A Product Support Bulletin From Service Engineering

Issue #	C14008
Level:	B
Issue Date:	5/29/2014
Expiration Date:	11/29/2014

Adjust factory settings prior to pre-delivery inspection.

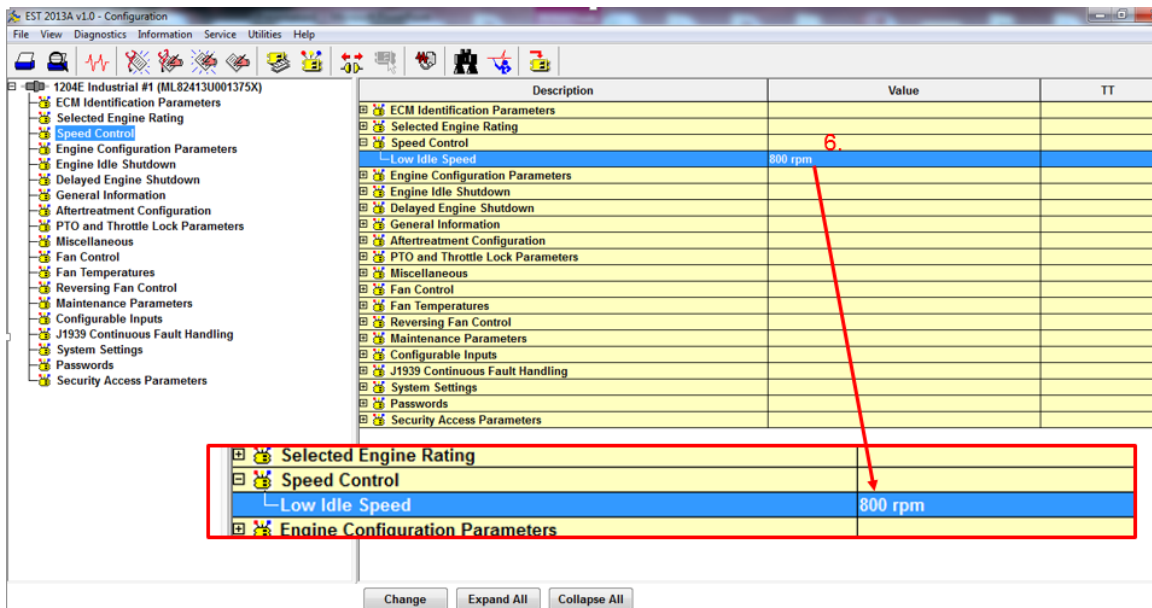
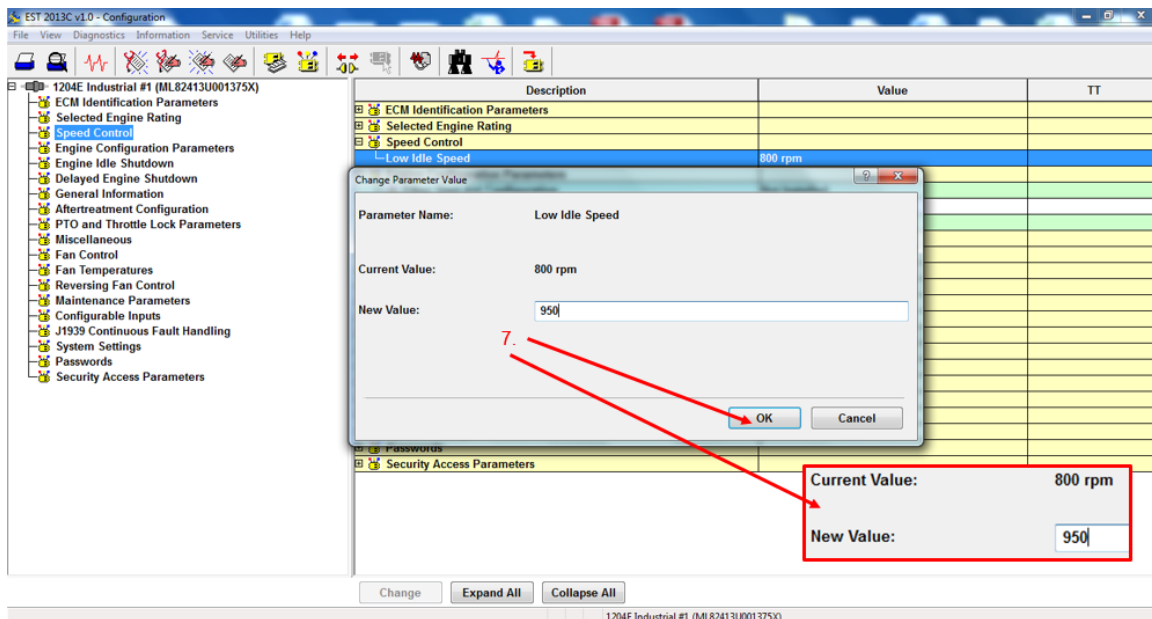
6. Find the Low Idle Speed Value of 800 and Double Click the value.

7. Input **950** in the New Value Box and click OK.

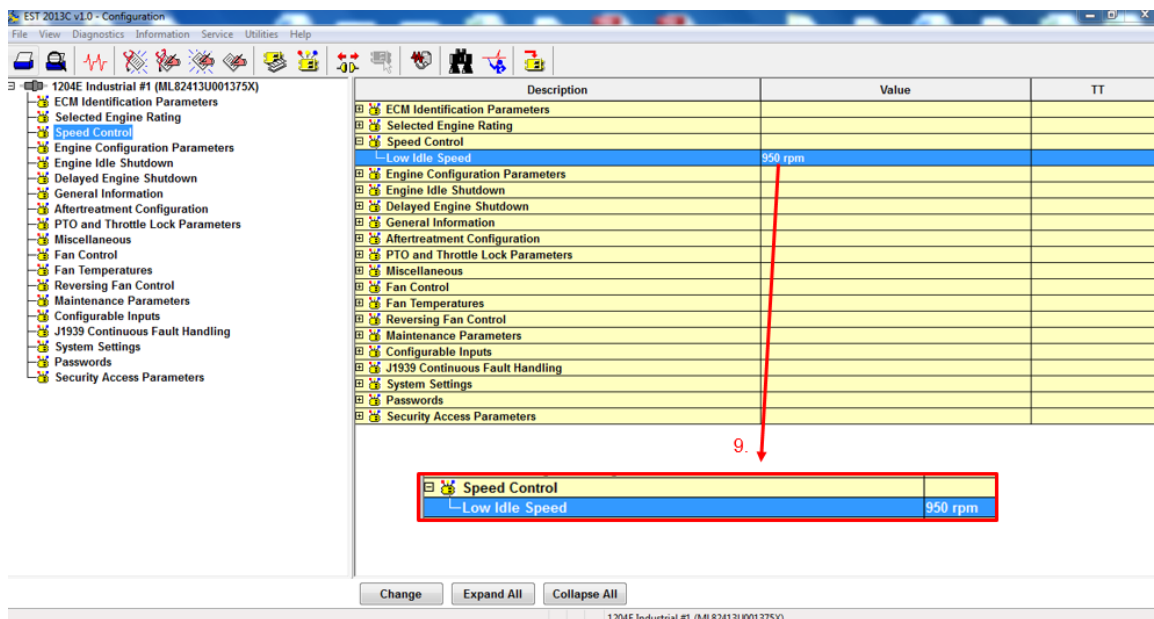
9. The dashboard will now reflect the new RPM value of 950.

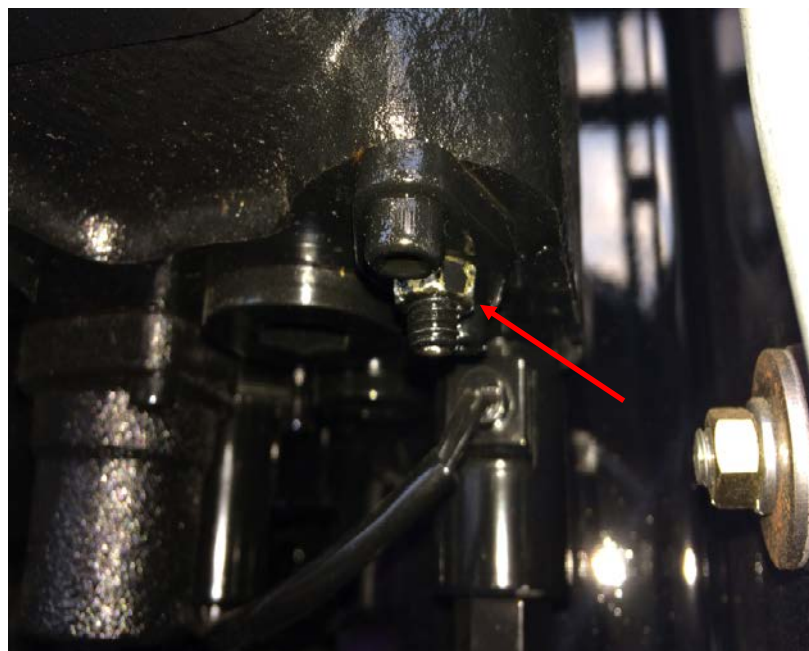
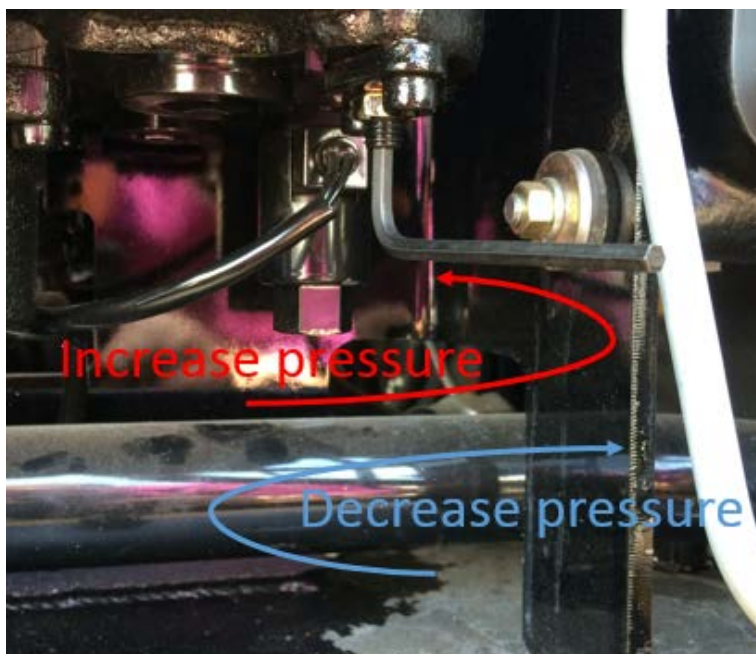
6. Use the 4mm hex key to adjust the main relief pressure.

7. Set the main relief pressure to 2700psi. Check the pressure at 100% throttle (WOT) at full back tilt.
